L-2001-036  
10 CFR 50.80  
10 CFR 50.90

Re: St. Lucie Units 1 and 2  
Docket Nos. 50-335, 50-389  
Turkey Point Units 3 and 4  
Docket Nos. 50-250, 50-251  
Application for Order and Conforming License Amendments  
Transfer of Operating Authority

**ENCLOSURE 3**

**SURVEILLANCE REQUIREMENTS**

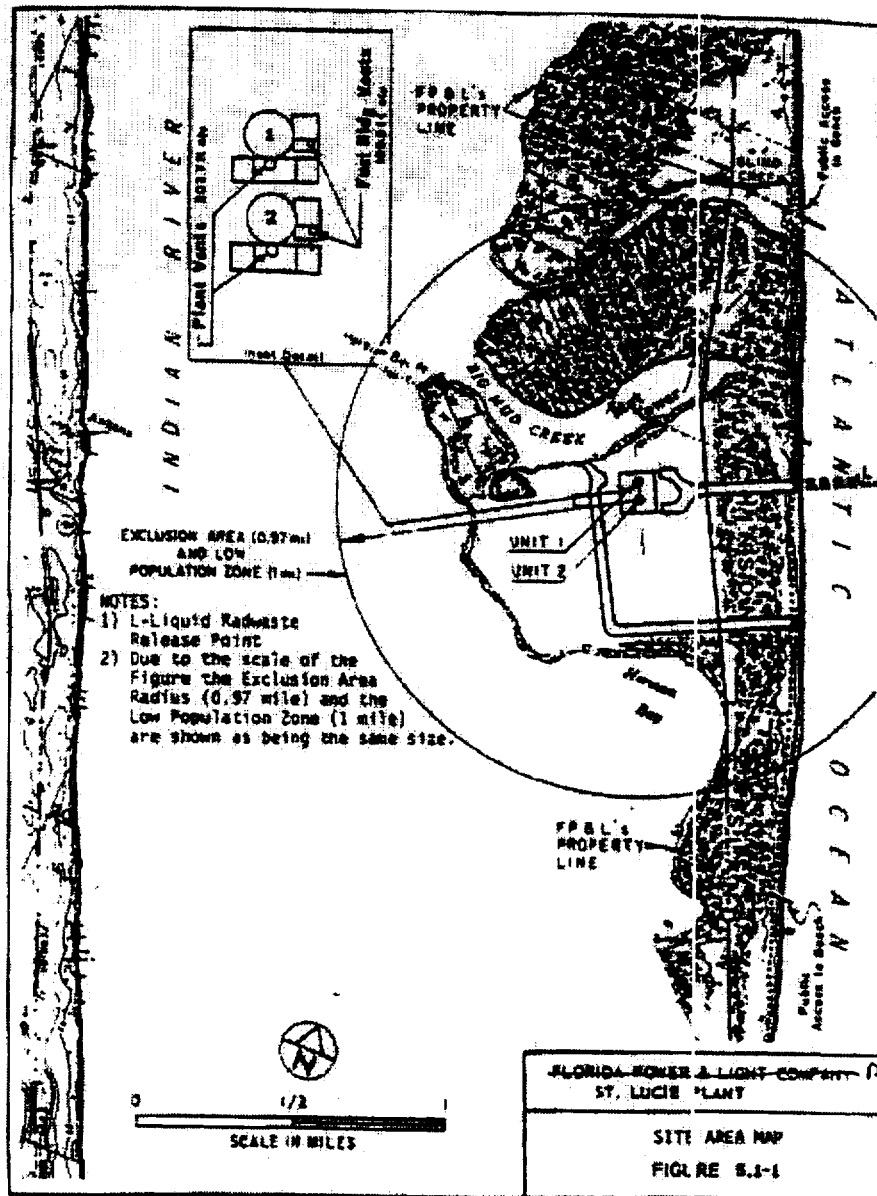
- a. The licensee, or *EWCB*
- b. Other persons specifically authorized by the Commission or an Agreement State.

4. Revise TS 4.7.9.1.1.a. to change [The licensee] to [WCB]
  5. Revise TS Figure 5.1-1 to delete reference to [Florida Power & Light Company] in the Figure title box

**SURVEILLANCE REQUIREMENTS**

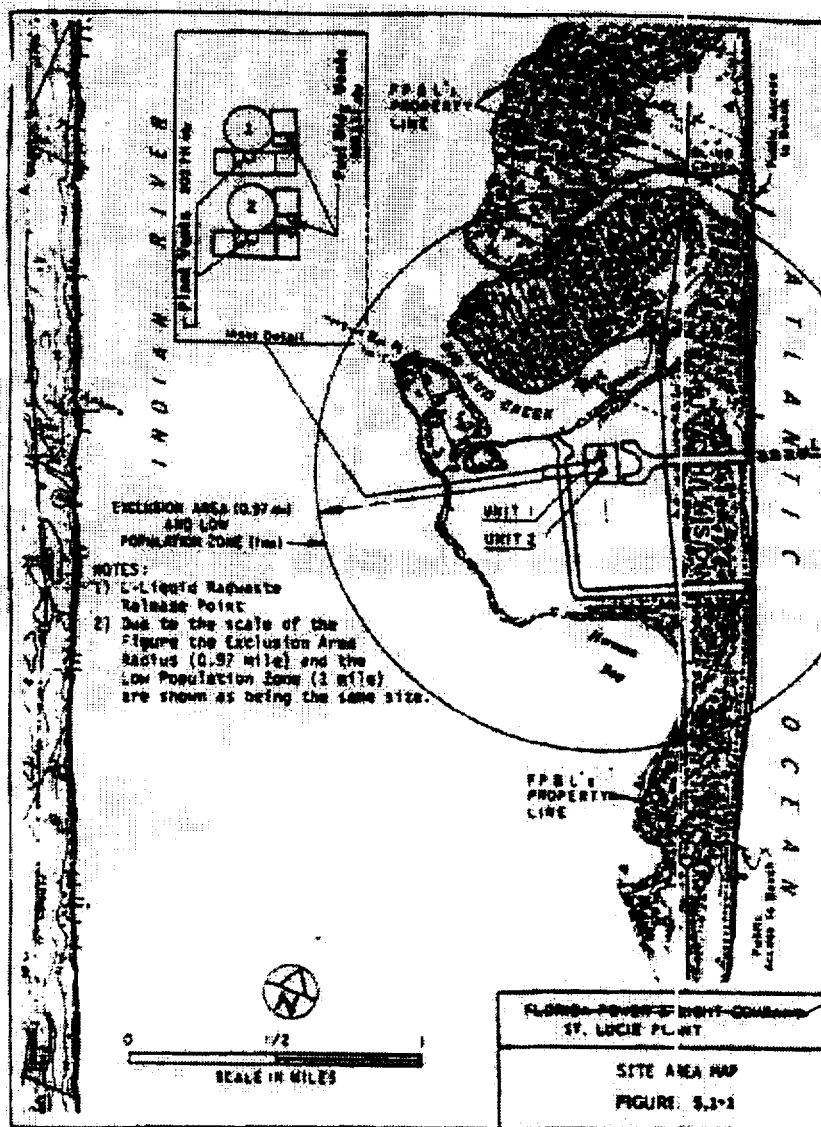
- a. ~~The licensee~~ or <sup>WCB</sup>
- b. Other persons specifically authorized by the Commission or an Agreement State.

4. Revise TS 4.7.10.1.a. to change [The licensee] to [WCB]
  5. Revise TS Figure 5.1-1 to delete reference to [Florida Power & Light Company] in the Figure title box
